Town of Surfside

RFQ 2022-05

Construction of Town of Surfside 96th Street Park

Addendum No. 4

1 MENS RESTROOM ELEVATION
SCALE: 1/2" = 1'-0"
A-4.1

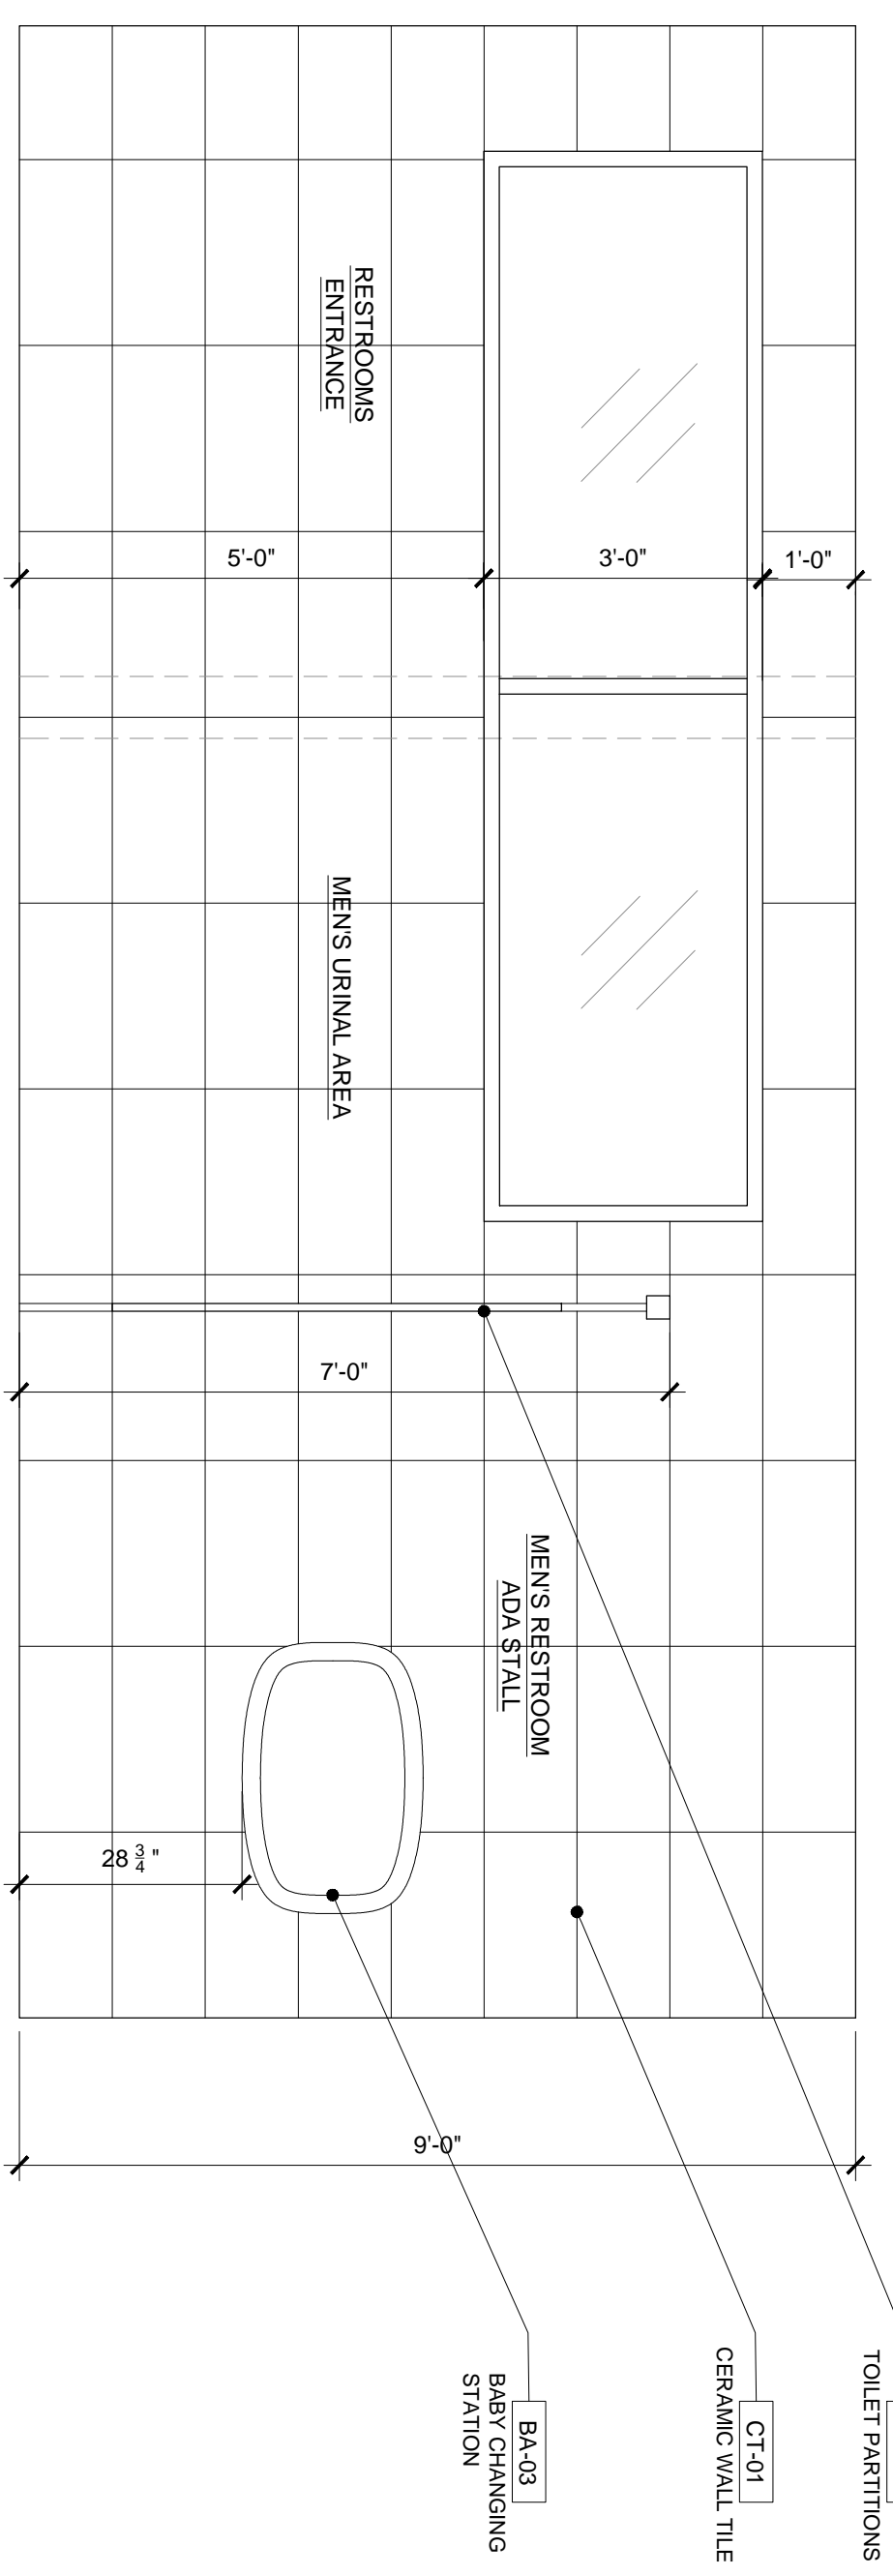
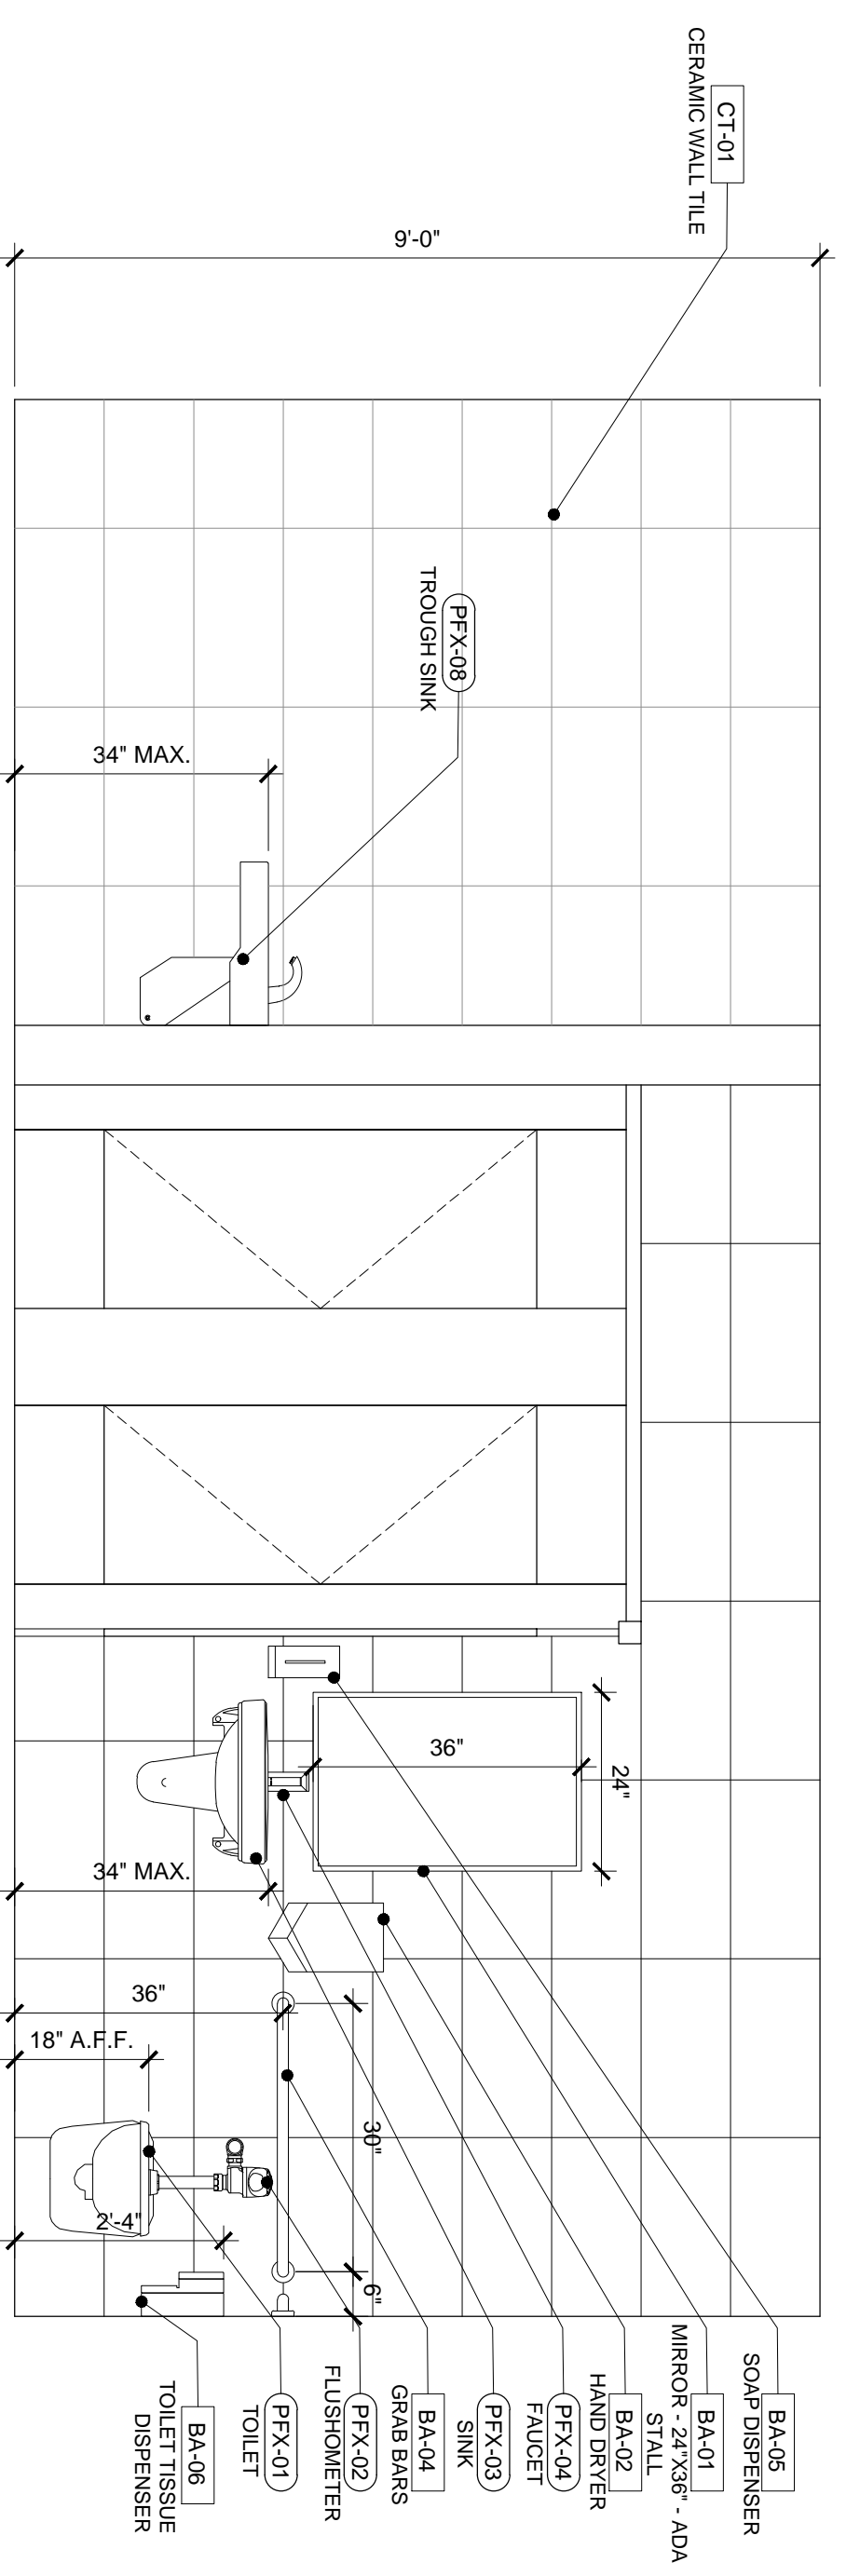
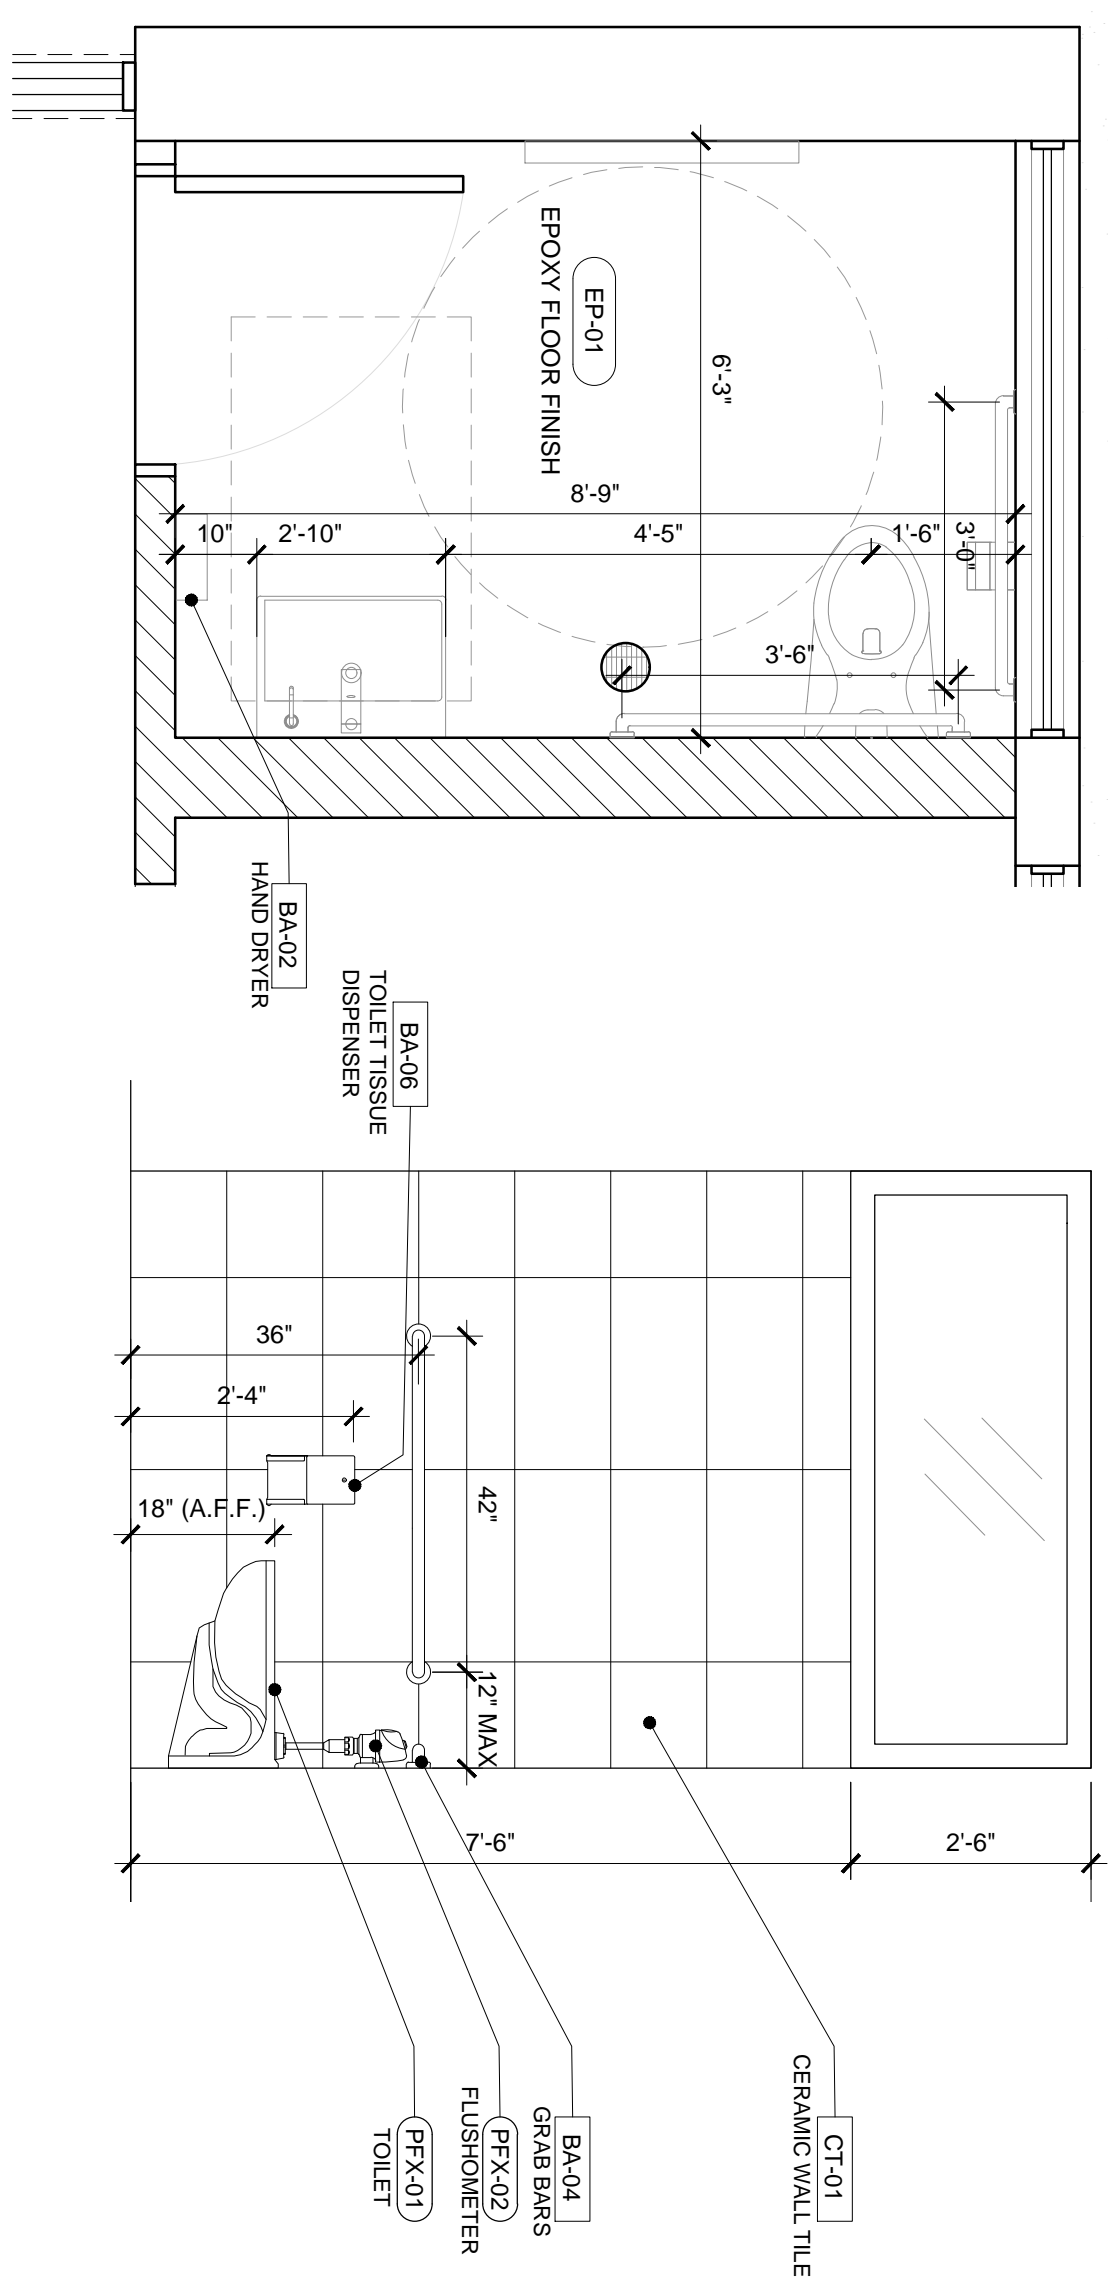
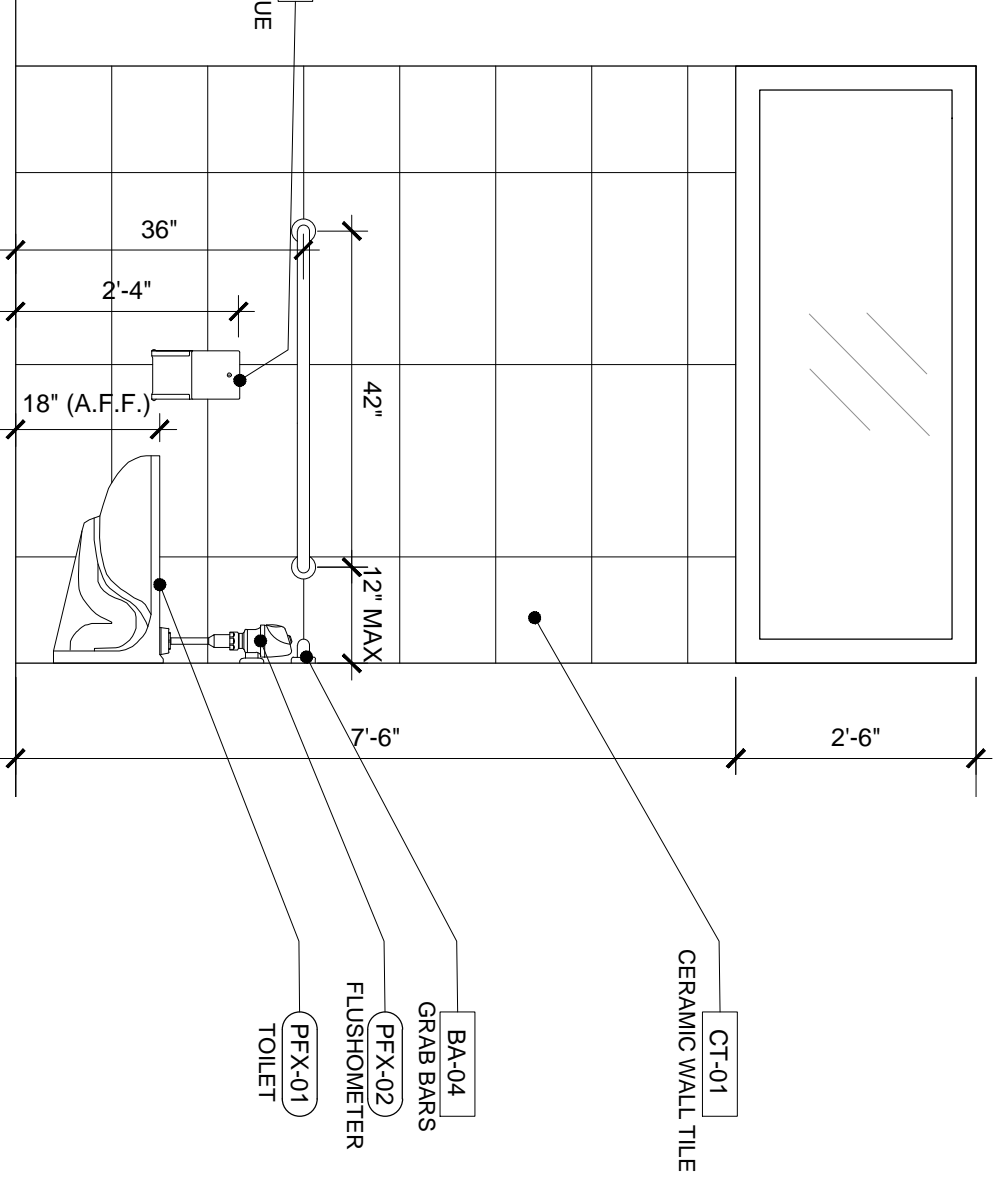
52. Plans do not specify any restroom accessories for the Second Floor Bathroom. Please provide.

See enlarged elevations for 2nd floor bathroom on sheet A-4.1. Provided tags for accessories and fixtures.
